City of Tualatin

ARCHITECTURAL REVIEW AND PUBLIC FACILITIES DECISION

AR-17-0010

Case #:	AR-17-0010
Project:	POR Durham Wireless Communication Facility
Location:	10290 SW Tualatin Road, Tualatin, OR, 97062
Tax Map/Lot:	2S1 23B 000800
Applicant/Owner:	Acom Consulting, Inc./TOTE-N-STOW INC.
Applicant/Rep.:	Reid Stewart, Acom Consulting, Inc., Gresham, OR reid.stewart@acomconsultinginc.com

SHEET NUMBER
SV2

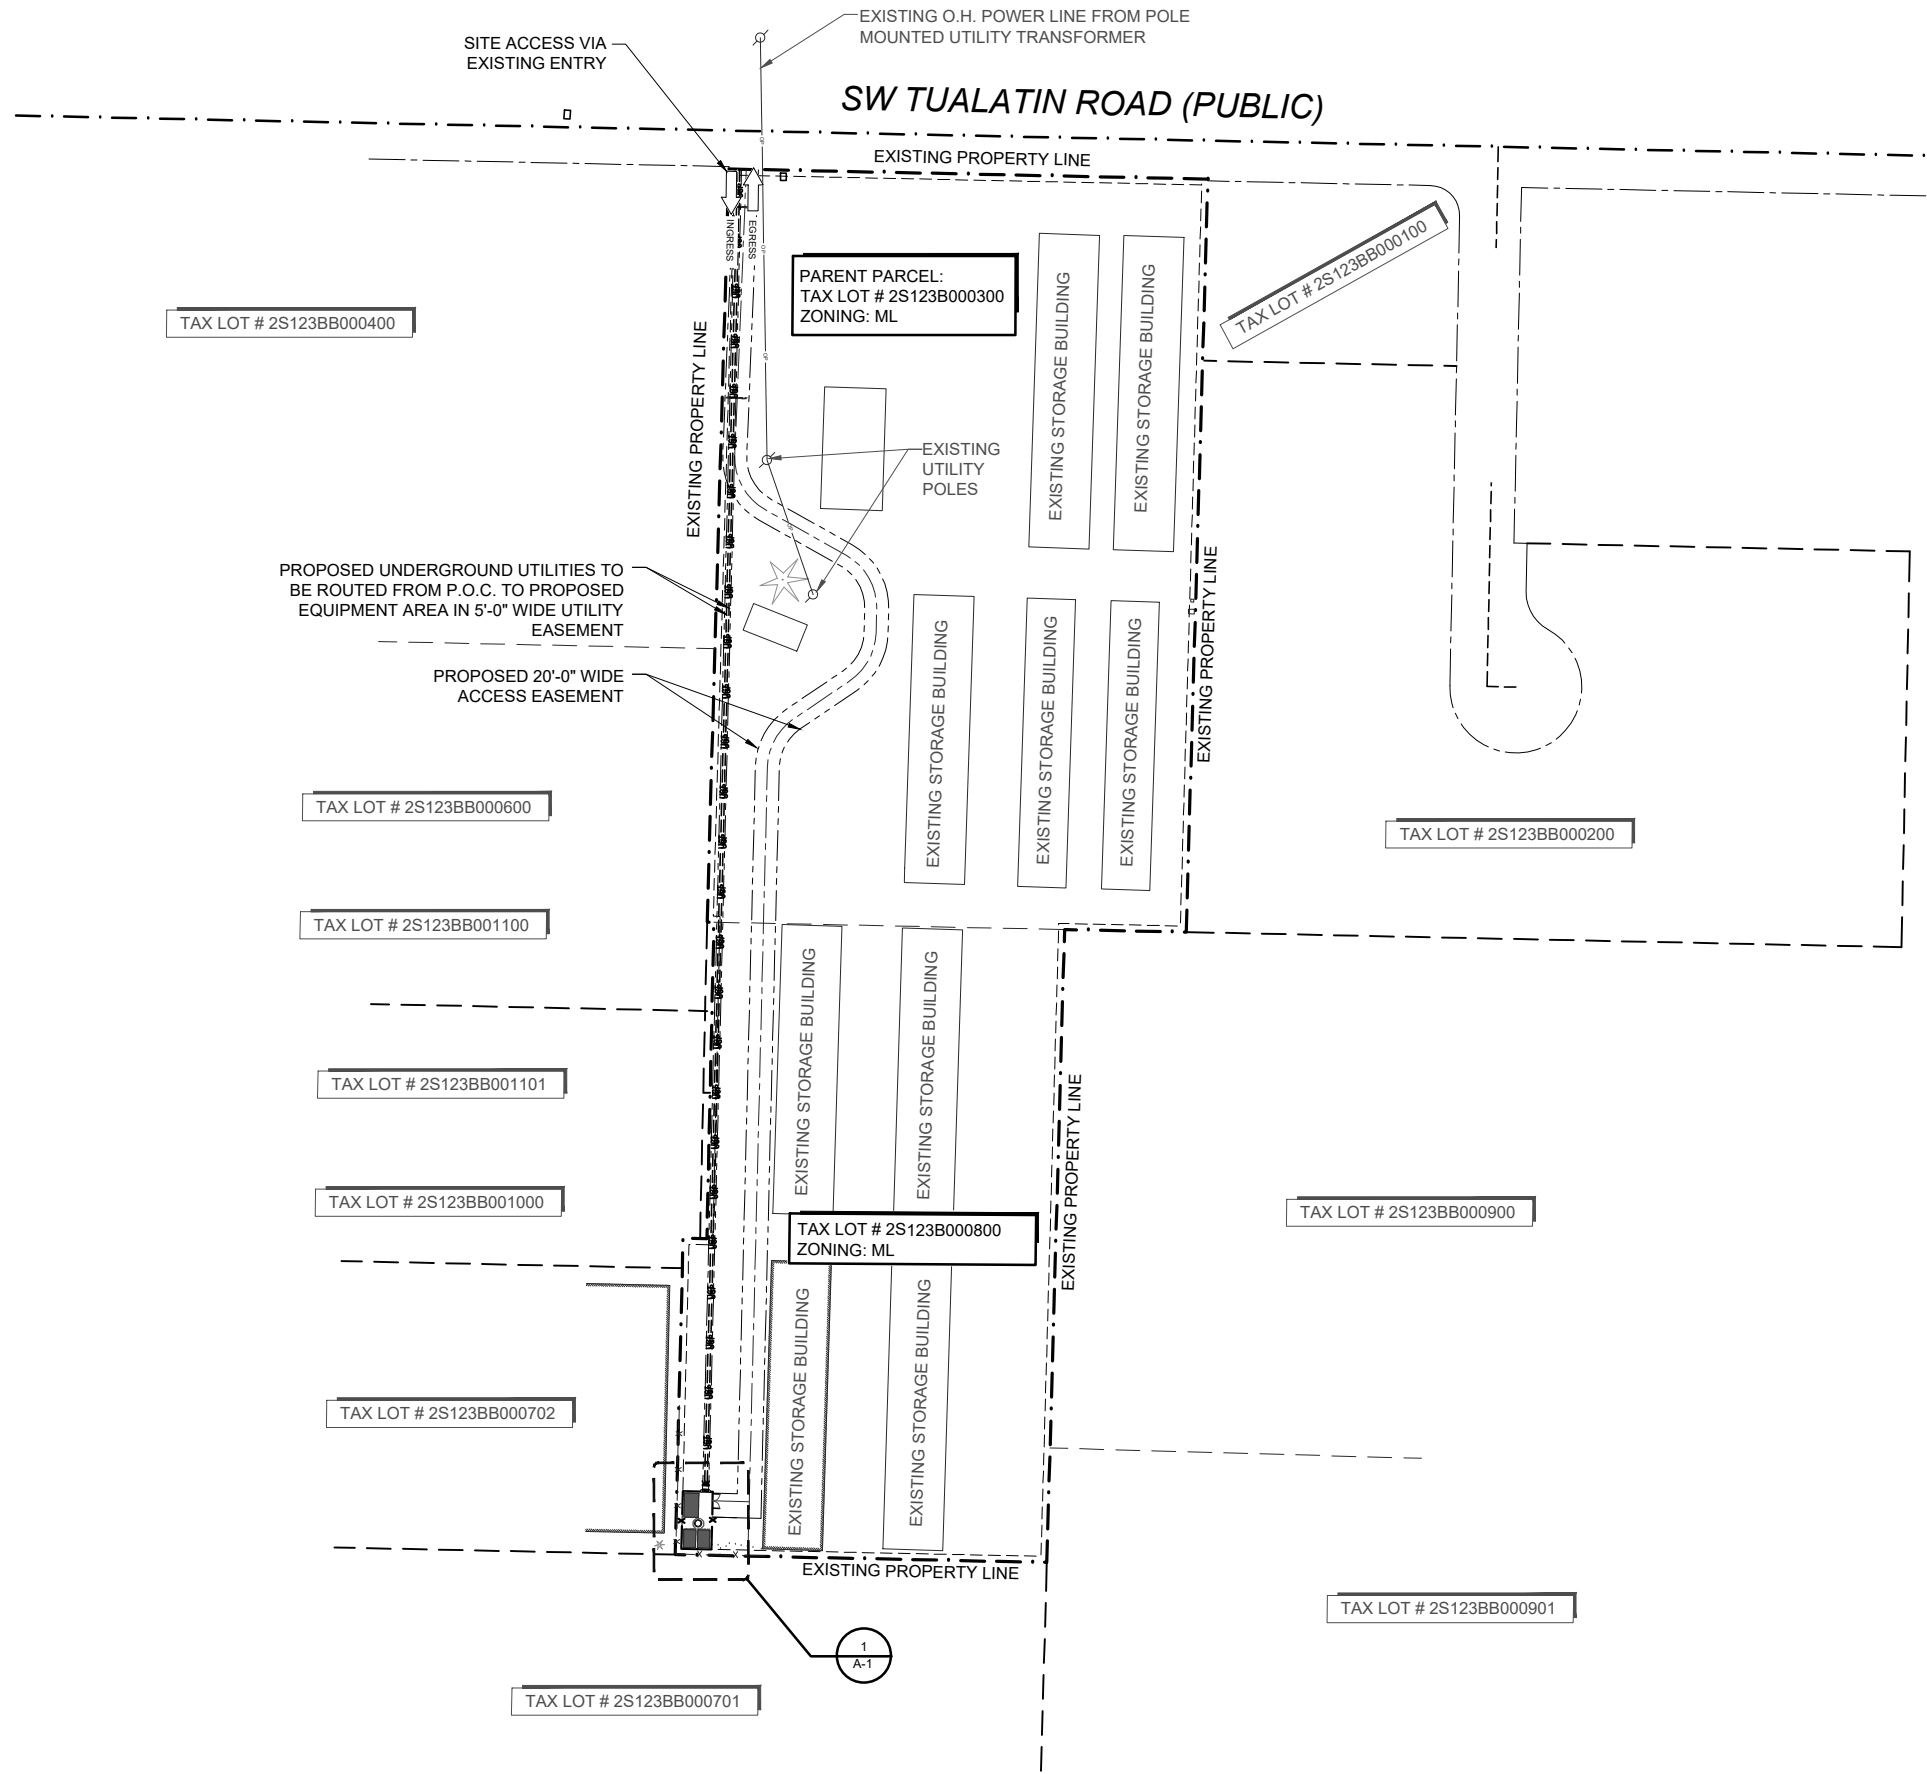
The applicant proposes temporary construction trenching for underground electrical and telecommunication conduit via a 5-foot-wide utility easement from the WCF to SW Tualatin Road (see Sheet SV2, dated December 16, 2016), but no permanent re-grading; therefore, staff finds that these standards do not apply.

Drawing Title:
PROPOSED EQUIPMENT PLAN

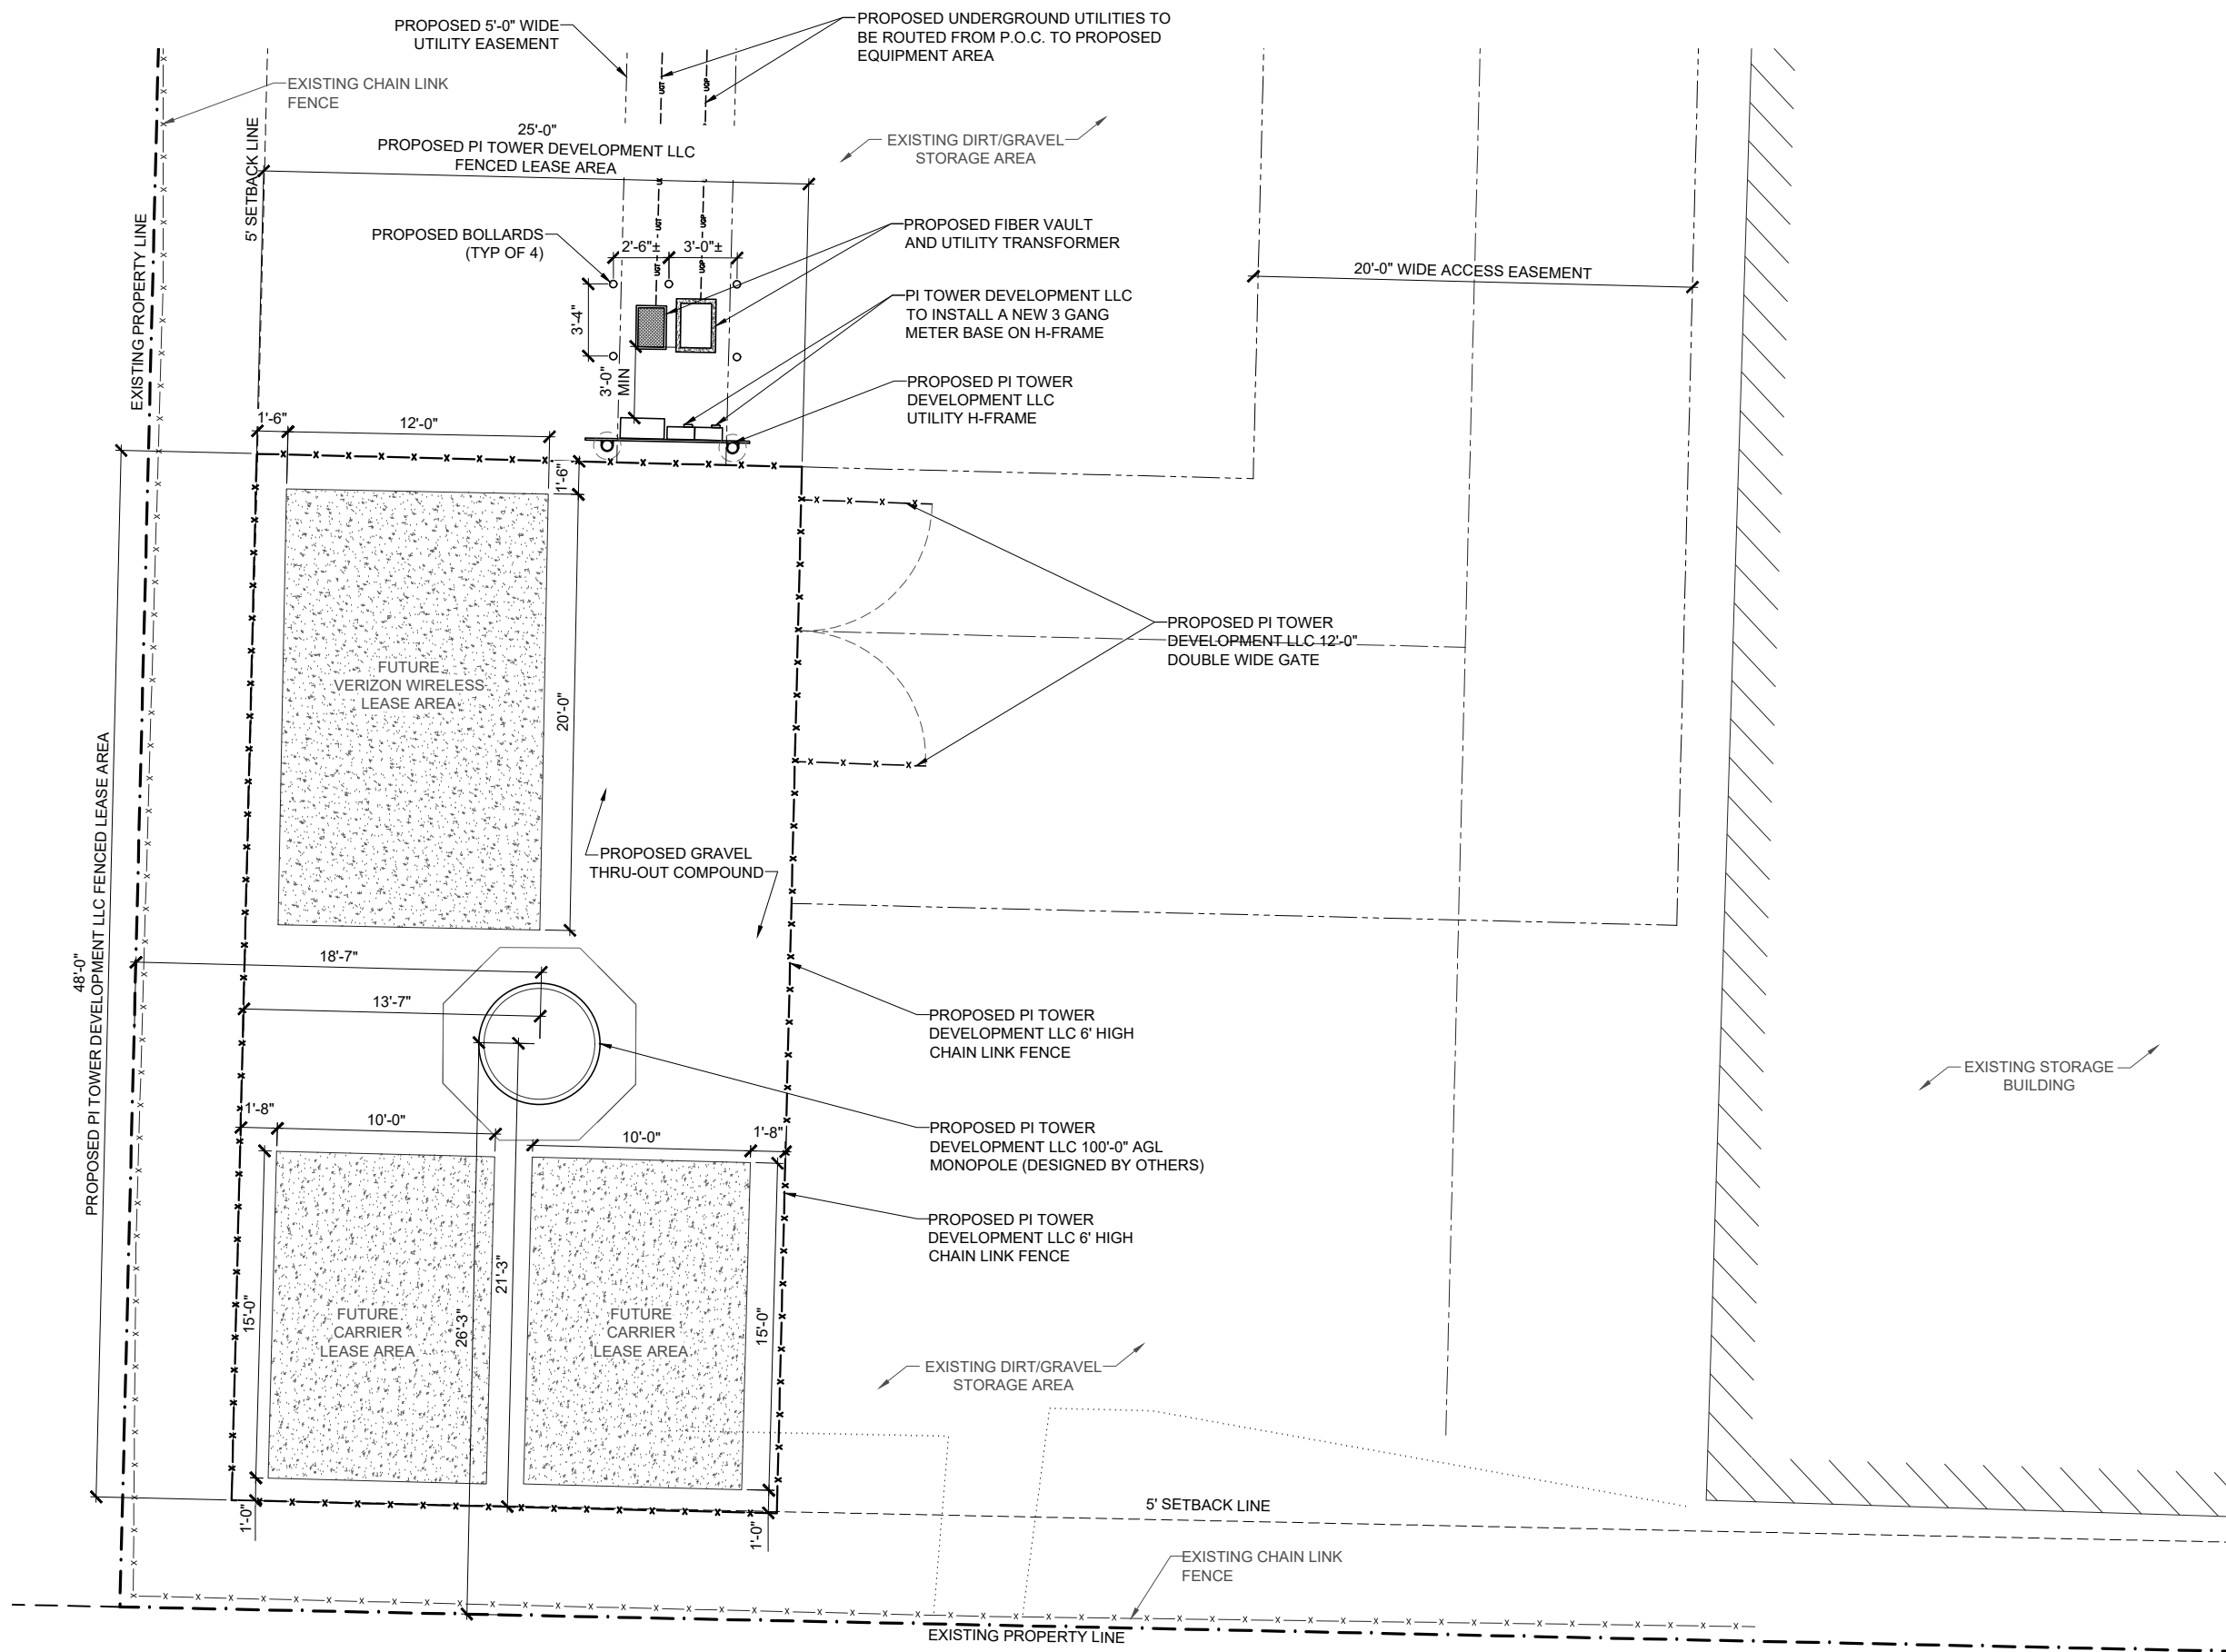
Staff finds that the above-referenced standards (1) through (7) do not apply. Staff finds that above-referenced standards (8) and (9) are met as shown in Sheets A-0—Site Plan and A-1—Proposed Equipment Plan, both dated March 6, 2017. Specifically, the property is comprised of two tax lots on one legal parcel. The tower sits near the southern portion of the property, on the southern tax lot. The property abuts an RL District on the north, across SW Tualatin Road. Because the tower is located to the far south of the long property, it is setback about 1,000 feet from the RL District. As such, the project complies with the setback requirements. See further setback discussion under TDC 73.510 below.

Staff finds that this standard is met. Staff notes that parking for the site technician (anticipated to visit the site once or twice a month) would be accommodated in the proposed access easement area adjacent and east of the lease area as shown in Sheet A-1—Proposed Equipment Plan, dated March 6, 2017. A condition of approval has been added to assure this easement is recorded.

Staff finds that these standards do not apply. Staff notes that WCFs are not required to have off-street parking lots, and that parking for the site technician (anticipated to visit the site once or twice a month) would be accommodated in the proposed access easement area adjacent and east of the lease area as shown in Sheet A-1—Proposed Equipment Plan, dated March 6, 2017.

A-2

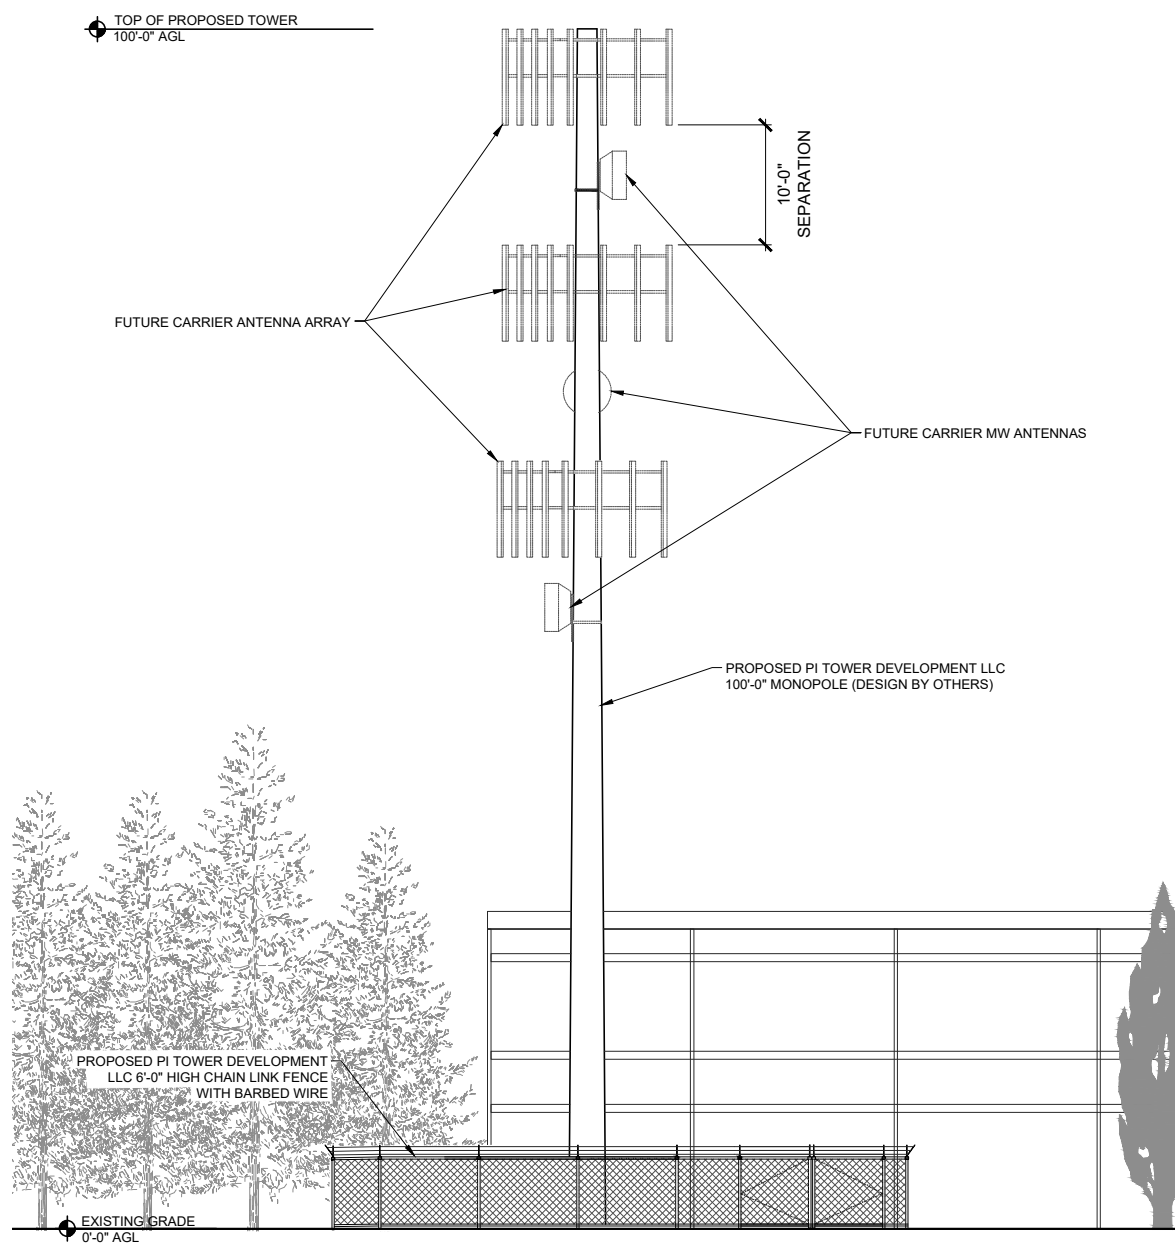
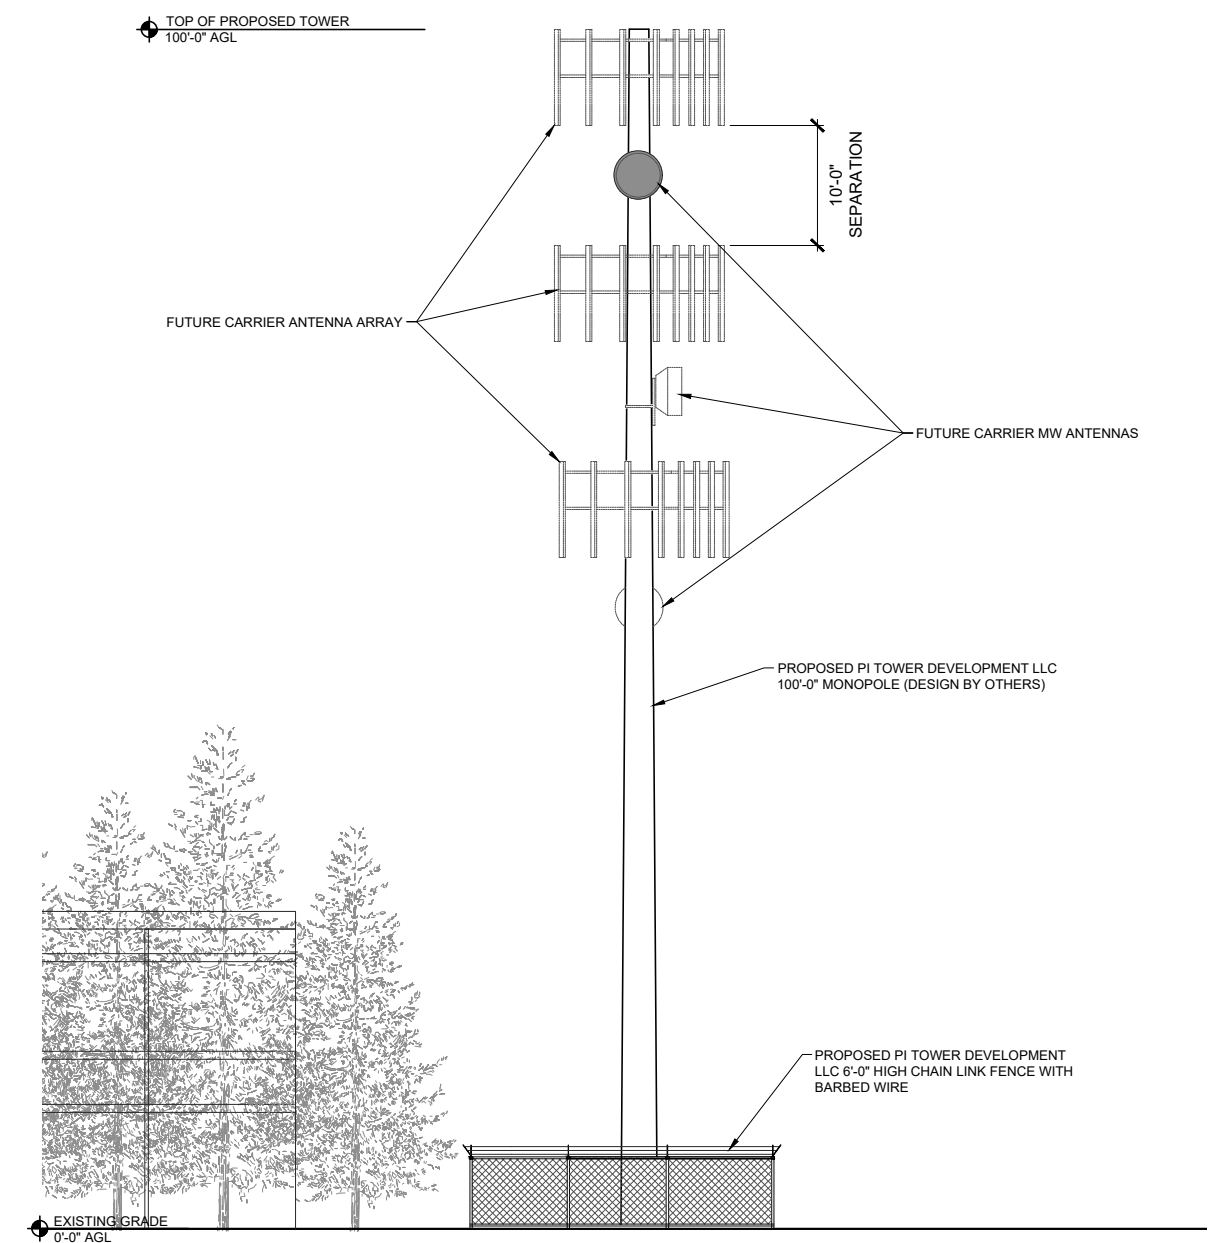
Staff finds that 60.090(4) standards are met as shown in Sheet A-2—Proposed Tower Elevations dated March 6, 2017. Staff finds that above-referenced standards (1), (2), and (3) do not apply.

Staff finds that the above-referenced TDC 73.160(4)(a) standard is met by a 6-foot-tall chain-link fence with vinyl slats as shown on Sheet A-2—Proposed Tower Elevations, dated March 6, 2017.

As the proposed WCF does not include an occupiable structure, lighting, or other public or semi-public space, staff finds that these standards do not apply. Staff notes that the proposed lease area will be defined by six-foot-tall fencing topped with barbed wire for security purposes as illustrated in Sheet A-2—Proposed Tower Elevations (dated March 6, 2017).

Staff finds that this standard is met by a 6-foot-tall chain-link fence with vinyl slats as shown on Sheet A-2—Proposed Tower Elevations, dated March 6, 2017.

Staff finds that this standard is met as shown on Sheet A-2—Proposed Tower Elevations, dated March 6, 2017.

Staff finds that this standard is met by a 6-foot-tall chain-link fence with vinyl slats as shown on Sheet A-2—Proposed Tower Elevations, dated March 6, 2017.

Staff finds that this standard is met as shown on Sheet A-2—Proposed Tower Elevations, dated March 6, 2017.

Staff finds that this standard is met. With the exception of the monopole and attached antennae, all other equipment associated with the proposed WCF would be screened by a 6-foot-tall chain-link fence with vinyl slats as shown on Sheet A-2—Proposed Tower Elevations, dated March 6, 2017.
